UNITED STATES PATENT AND TRADEMARK OFFICE

APPLICATION NO.	FILING DATE	FIRST NAMED INVENTOR	ATTORNEY DOCKET NO.	CONFIRMATION NO.
10/699,648	11/04/2003	Naoya Ishikawa	953.1012	5367

Office Action Summary

DETAILED ACTION

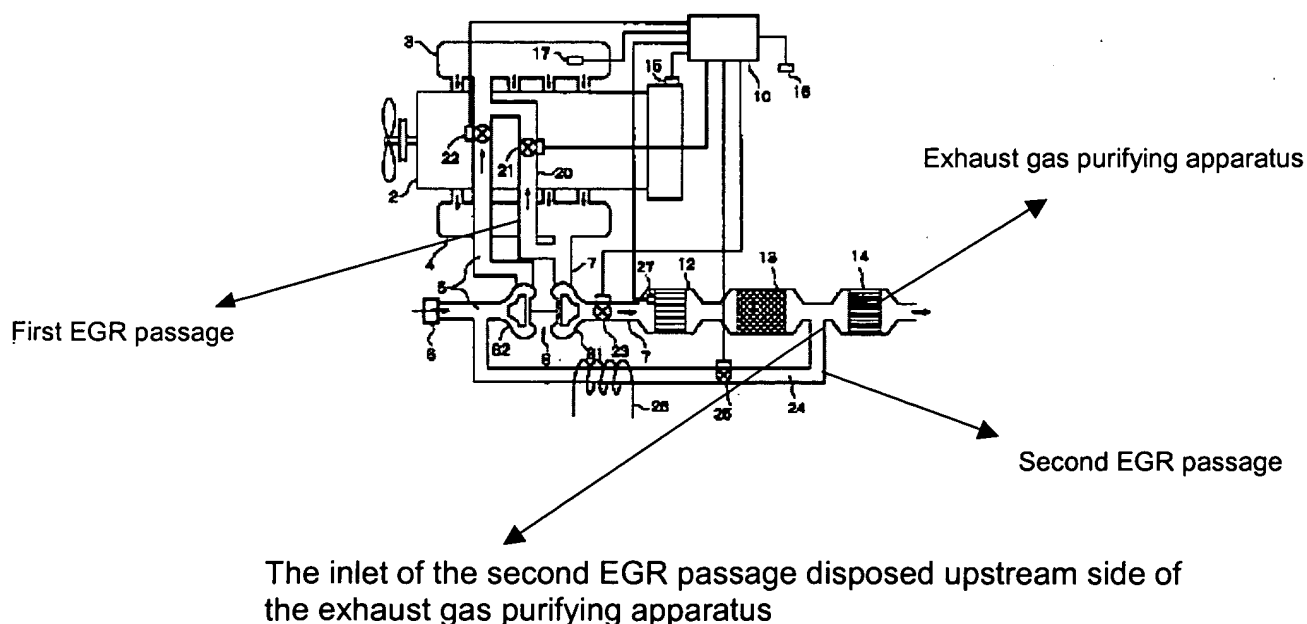
Minami discloses an EGR system for an internal combustion engine (2) with a turbocharger (8), comprising a first EGR passage (Not Numbered, Read as a passage including valve 21) for recirculating a part of the exhaust gas from the upstream side of a turbine (81) of the turbocharger (8) to the downstream side of a compressor (82) of the turbocharger;

wherein a second EGR passage (24), comprising an inlet (Not Numbered), for recirculating a part of the exhaust gas from the downstream side of said turbine (81) to the upstream side of said compressor (82), a flow control means (21) for controlling the exhaust gas in said first EGR passage (Read as a passage including valve 21) and said second EGR passage (24), an exhaust gas purifying apparatus (14), an EGR control means (25) for controlling the flow control means based on data detected by an exhaust gas state monitoring means are provided;

wherein the second EGR passage being branched out on an upstream side of the exhaust gas purifying apparatus, and the inlet of the second EGR passage is disposed upstream side of the exhaust gas purifying apparatus (14) (See Figure 1, Paragraphs from [0025] to [0028]);

wherein the flow control means being composed of the first EGR valve (21) arranged in said first EGR passage and the second EGR valve (25) arranged in said second EGR passage, and the EGR control means (10) controls the exhaust gas flow by controlling said first EGR valve (21) and said second EGR valve (25) to be open/closed said exhaust gas state monitoring means being composed of an exhaust gas temperature sensor arranged in said exhaust passage, and the EGR control means controls the exhaust gas flow by controlling said first EGR valve and said second EGR valve to be open/closed based on the exhaust gas temperature detected by the exhaust gas temperature sensor (See Figure 1, and Paragraphs [0012] and [0013]); and

wherein when said exhaust gas detection temperature is not higher than the regeneration temperature of said diesel particulate filter, said first EGR valve is controlled to be open, while said second EGR valve is controlled to be closed, and when said exhaust gas detection temperature is higher than the regeneration temperature of said diesel particulate filter, said second EGR valve is controlled to be open (See Paragraphs [0012], [0013], [0014], [0015], [0016], and [0017]).

However, Minami fails to disclose the location of the diesel particulate filter being in the second EGR passage after the second EGR passage is branched out of the main exhaust gas passage; and the exhaust gas purifying apparatus comprising the diesel particulate filter and NOx purifying catalyst converter.

EGR passage disposed upstream side of the turbine

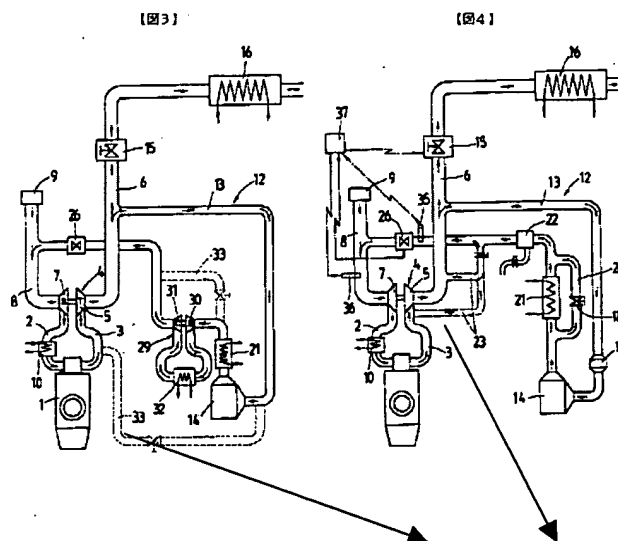
Yasuma teaches that it is conventional in the turbocharged internal combustion engine art, to utilize an inlet of the second EGR passage being arranged at the upstream side of said turbine (via 33, 14, 30, 29, 31, 26, 8) (See Figures 3, 4, and 6).

It would have been obvious to one having ordinary skill in the art at that time the invention was made, to have utilized an inlet of the second EGR passage being arranged at the upstream side of said turbine, as taught by Yasuma, to improve the reduction of exhaust emissions, in the modified Minami diesel engine.
